**Town of Middlesex
Emergency Watershed Program**

**Addendum No. 1
September 18, 2024**

TOWN OF MIDDLESEX
USDA EWP PROJECT
MIDDLESEX, VERMONT

DSR NO. 5041-019 AND 227
15 AND 19 SUNNY BROOK ROAD
DEBRIS REMOVAL - PROFILE & SECTIONS

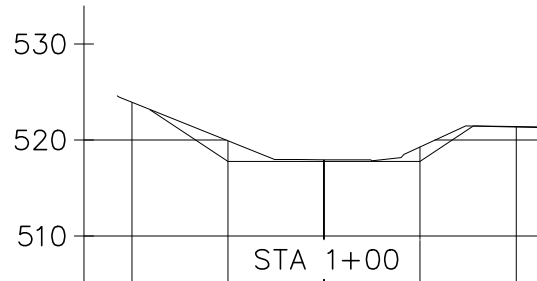
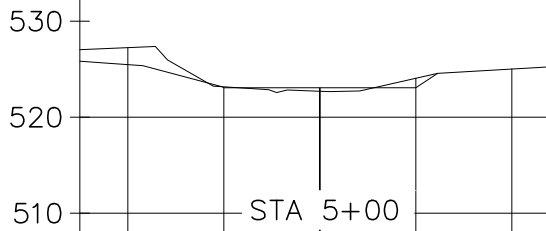
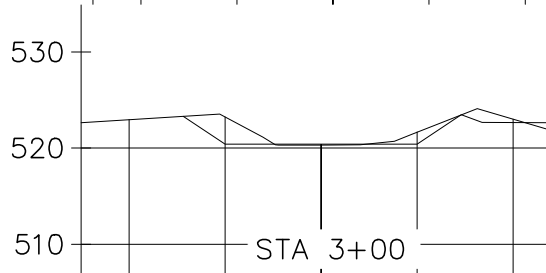
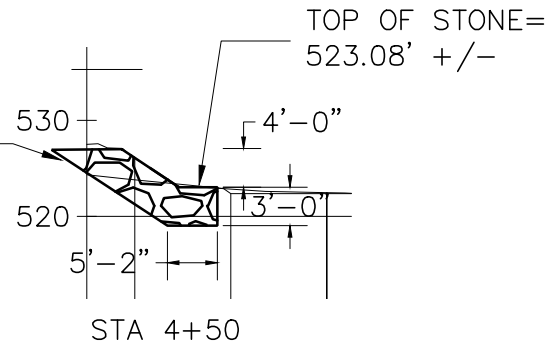
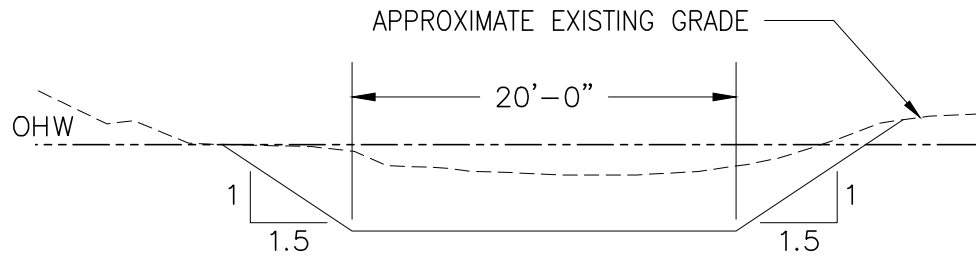
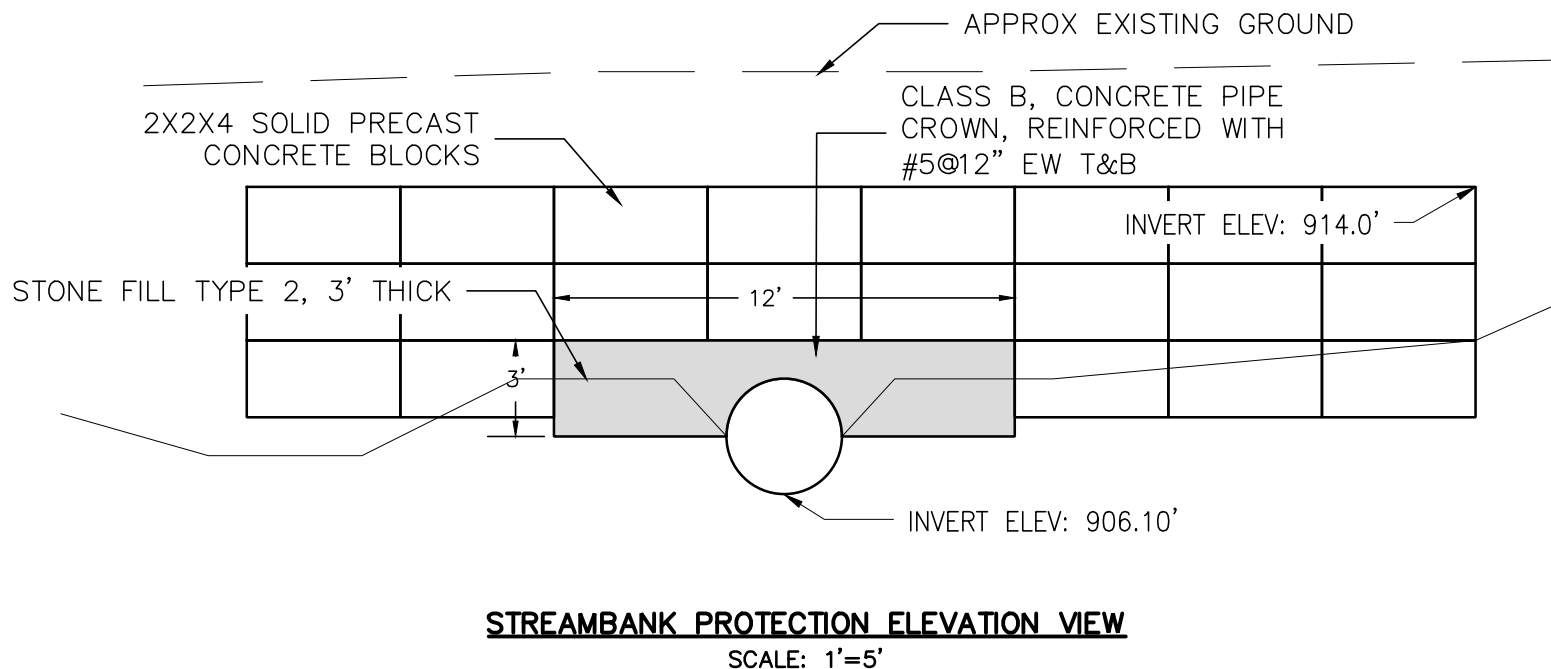
9. An attendee asked for elevations for rip rap at 19 Lower Sunny Brook Rd
10. USDA will be seeking a breakdown of cost per site.

1. Delete Sheets 17-19 and all work at 56 Macey Road.
2. Attached is revised Sheet No 23 (Rev 1).
3. Attached is revised Sheet No 26 (Rev 1).

DSR NO. 5041-024
125 CULVER HILL ROAD
STREAMBANK PROTECTION -DETAILS

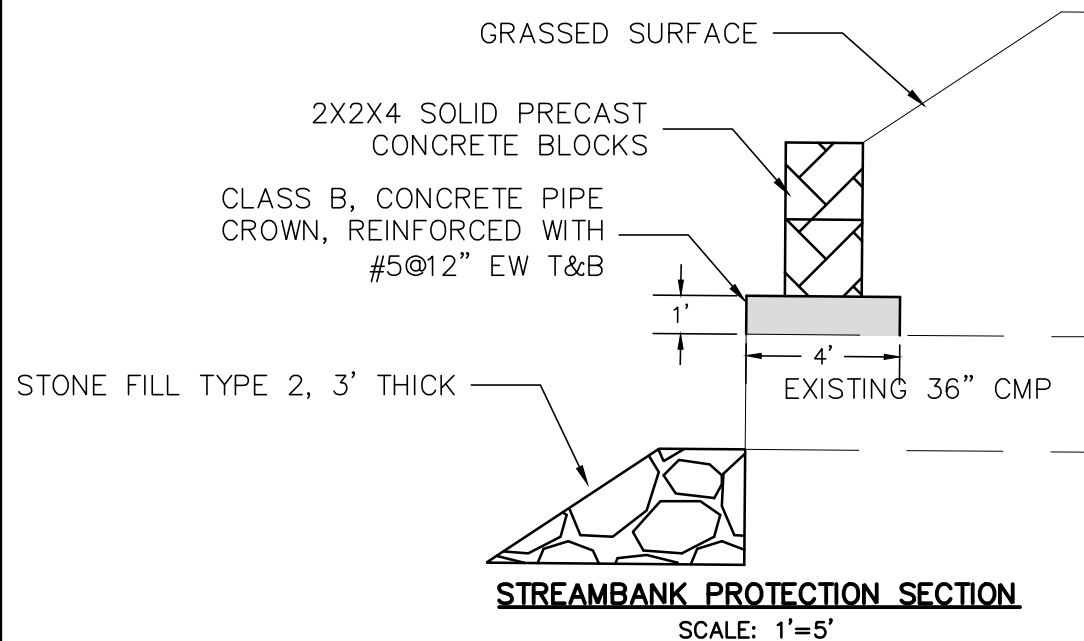
6. Attendance at the site visit is not mandatory.
7. The site conditions at 33 Meade Rd have changed due to property owner debris removal.
8. An attendee requested dimensions for the concrete at 125 Culver Hill Rd.
